SERVICE DIRECTIVE BULLETIN NO. 0062
Revision 1

DATE: March 28, 2025

1. SUBJECT: Belt Tensioning and Idler System Modifications
2. MODEL: F-28A, 280, F-28C, F-28C-2, F-28C-2R, and 280C
3. EFFECTIVITY: All serial numbers manufactured prior to January 1981
4. BACKGROUND:

Figure 1. Dimension Check for Actuator Arm Clearance

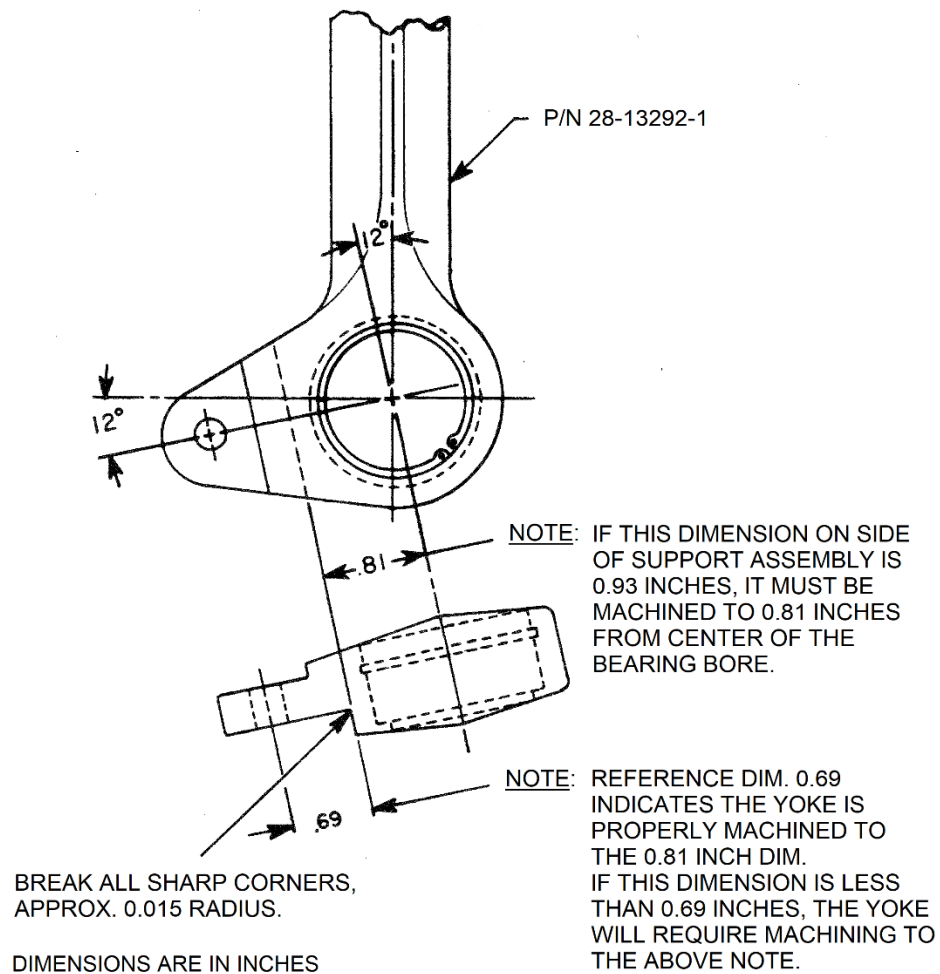
NOTE: Some early model F-28A helicopters may have an idler support assembly, P/N 28-13292-1 installed that may require an additional modification to accept the new actuator arms. See Figure 1 for dimensional check prior to assembly. If dimension is found to be 0.93 inch it should be machined locally to 0.81 inch for proper actuator arm clearance. (Reference Maintenance Manual Section 8, for idler assembly removal procedure.)
